**S.75W MODIFICATION TO MP10\_0057 – RESPONSE TO ISSUES  
132-138 KILLEATON ST, ST IVES**

I refer to the above matter and the letter to you addressed from Ku-ring-gai Council (dated 20 October 2011) and provide a response as follows.

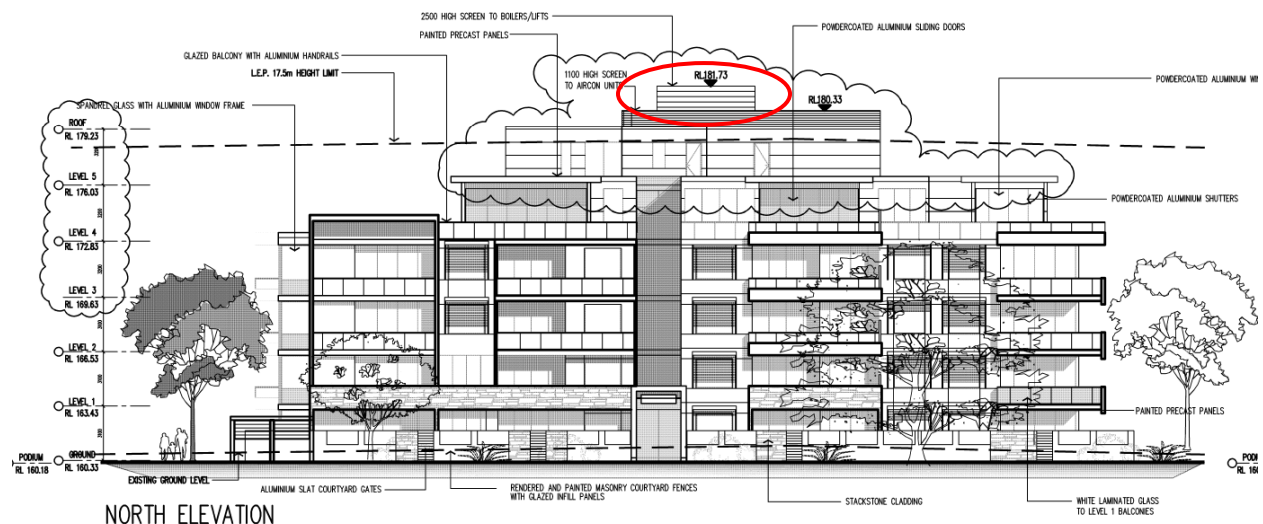
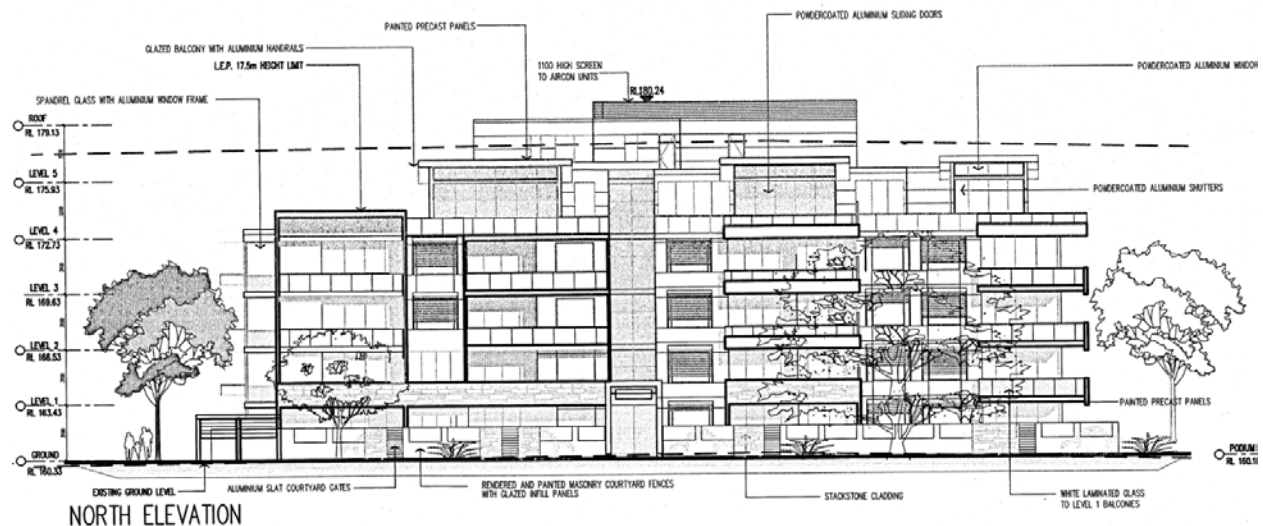
Council has stated that because the Town Centres Local Environmental Plan was found to be invalid, the definition of building height should revert back to the Ku-ring-gai Planning Scheme Ordinance. Council refer to Clause 25(1)5 of the Planning Scheme stating that a residential flat building on a site in-excess 2,400sqm should have a maximum of five storeys. Further, Council states that the definition of "storey" excludes uses that are solely for car parking or plant when they have a height of less than 1.2m above ground level.

In response to Council's comments above we provide the following response. Firstly, the original plans submitted with the Modification have been reviewed and the overall building height has been substantially reduced. The plans have been amended to show a 100mm increase from levels 3 to the roof for Building B, where previously we proposed a 770mm increase in height.
